SIMI VALLEY UNIFIED SCHOOL DISTRICT

BOARD APPROVED ITEMS FROM THE 9.10.24 BOE MEETING

TITLE: APPROVAL OF CHANGE ORDER NO. 1 TO LEASE LEASEBACK B24LS424, SIMI VALLEY HIGH SCHOOL MPR DEMOLITION PROJECT, INCREMENT 1

TITLE: APPROVAL OF CHANGE ORDER NO. 1 TO PARKVIEW CLASSROOM RENOVATIONS, B24FS412

CLASSROOM #31

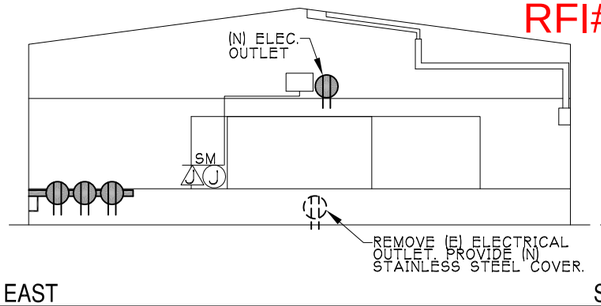
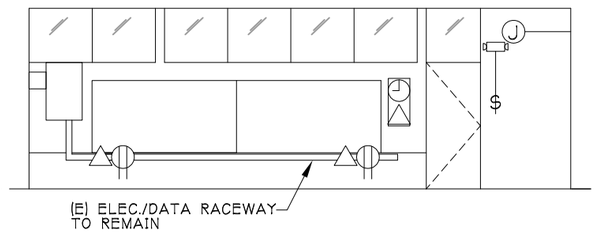
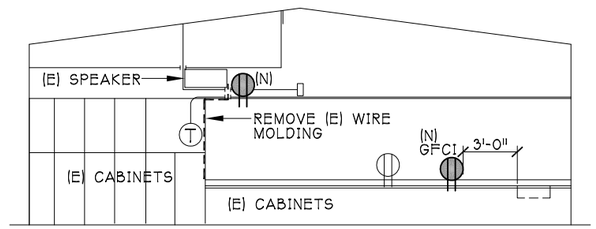
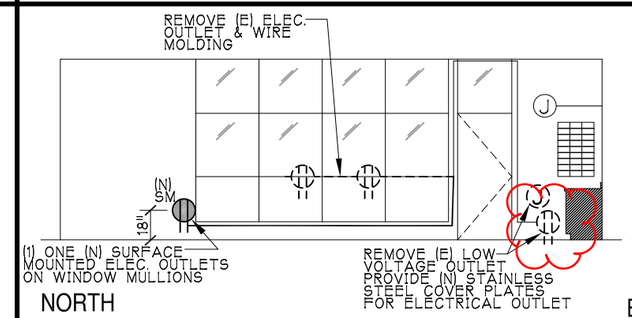
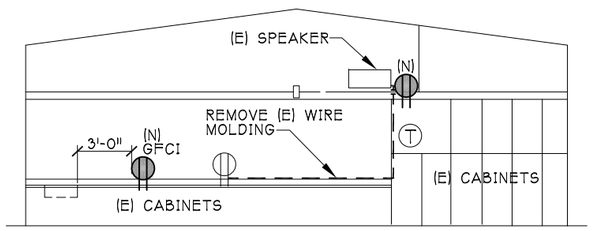
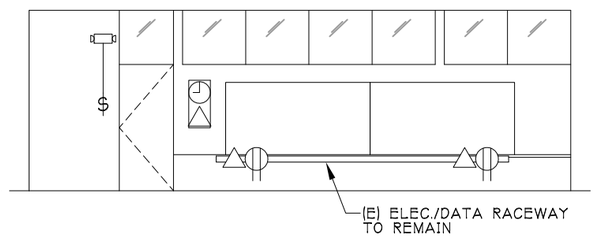
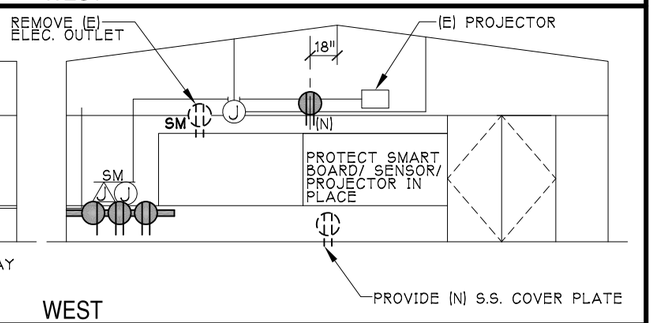
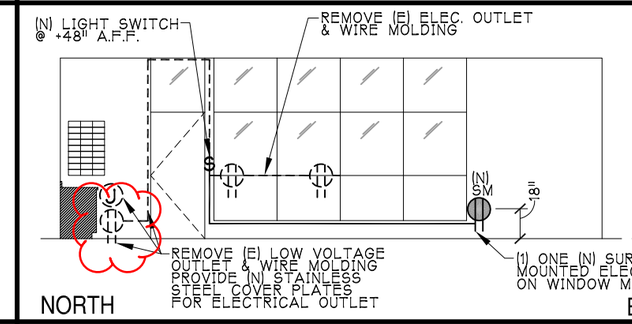
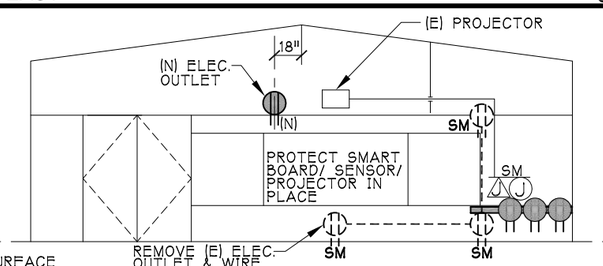
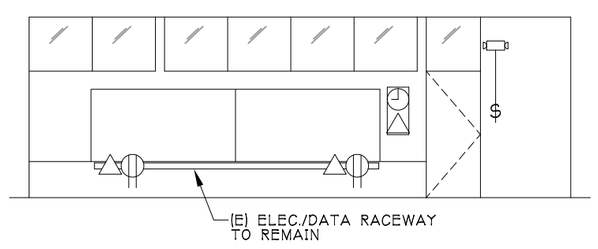
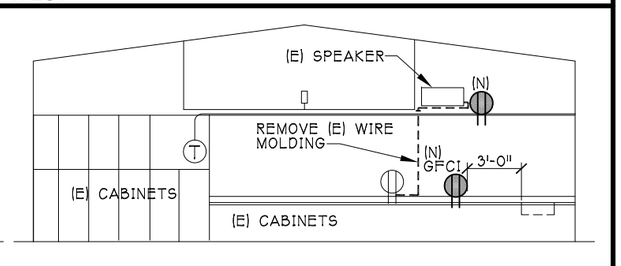
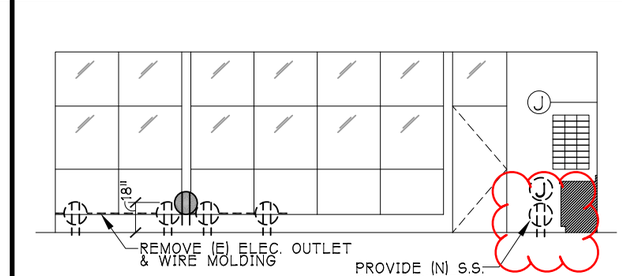
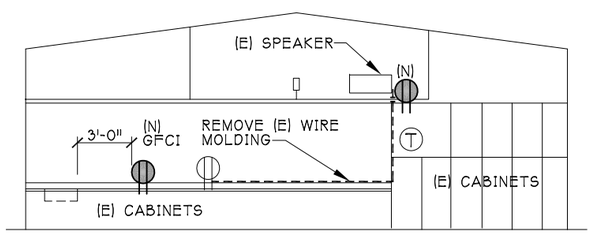
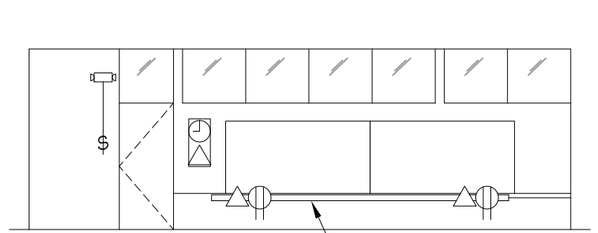
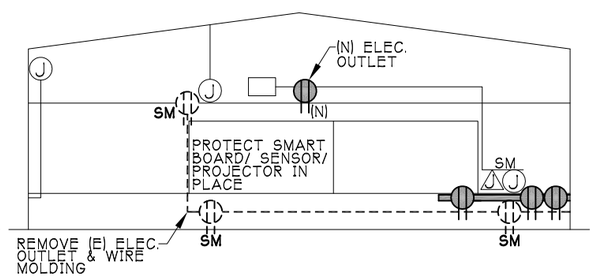
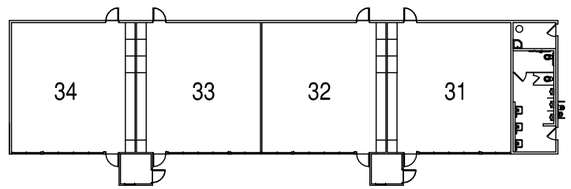
Patch holes in floor after removal of the existing heater grills in classrooms 31,32,33,34 (building 6). Refer to RFI #2 for additional information.

Patch holes in floor after removal of the existing heater grills in classrooms 31,32,33,34 (building 6). Refer to RFI #2 for additional information.
